ISSUE: Permit to Demolish/Capsulate (partial) and Certificate of Appropriateness for alterations

APPLICANT: Henry M TR and Ann K TR Handler

LOCATION: Old and Historic Alexandria District
427 North Saint Asaph Street

BAR #2022-00125 and BAR #2022-00130
427 North Saint Asaph Street

SURVEY SHOWING
NEW ADDITIONS

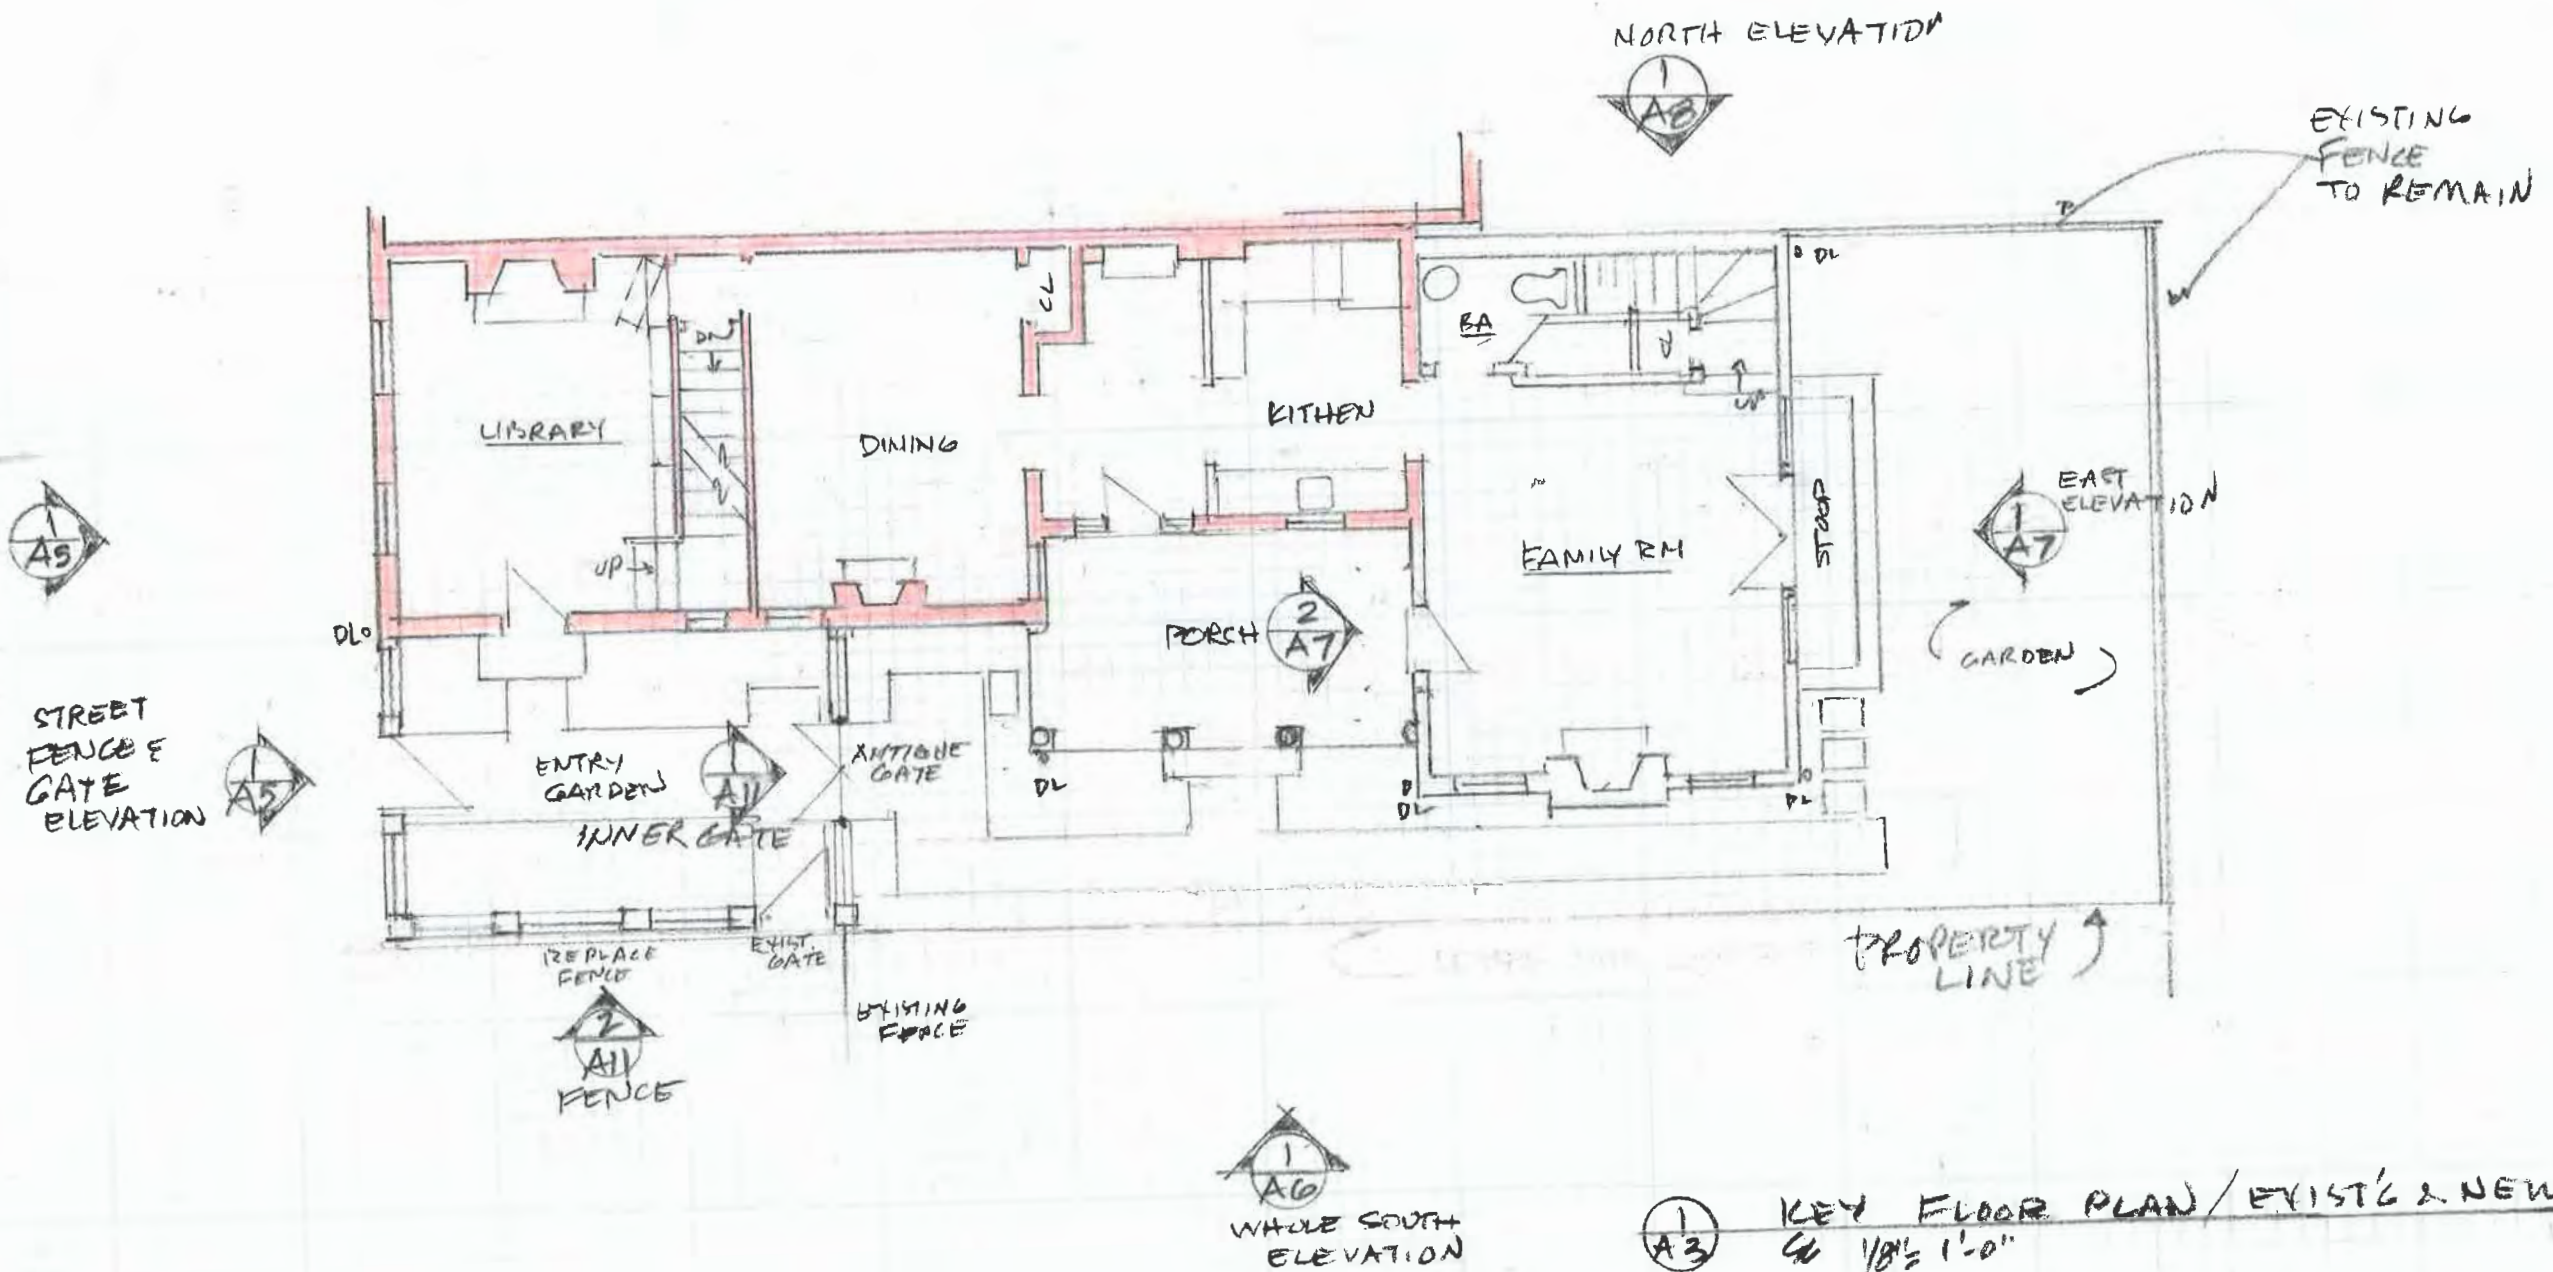
- F-2 There are slight inconsistencies in the plans showing the measurement of the chimney projection. Per Section 7-202(A)(4), chimneys cannot reduce the width of the side yard to less than 5.00 feet. The plans must be revised when submitting for building permit to show that the chimney is at least 5.00 feet from the south side yard property line.

- F-2 There are slight inconsistencies in the plans showing the measurement of the chimney projection. Per Section 7-202(A)(4), chimneys cannot reduce the width of the side yard to less than 5.00 feet. The plans must be revised when submitting for building permit to show that the chimney is at least 5.00 feet from the south side yard property line.

- F-1 The proposed brick piers and fence along the front property line exceed 4.00 feet in height; however, they are behind the front building wall and therefore are in the side yard, not the front yard. Because of this, they are allowed to be up to 6.00 feet in height and do not require a waiver from the BAR for height.
- F-2 There are slight inconsistencies in the plans showing the measurement of the chimney projection. Per Section 7-202(A)(4), chimneys cannot reduce the width of the side yard to less than 5.00 feet. The plans must be revised when submitting for building permit to show that the chimney is at least 5.00 feet from the south side yard property line.
- F-3 The proposed alterations, porch addition, and two story rear addition comply with zoning. The chimney will comply with zoning if it is at least 5.00 feet from the south side yard property line.
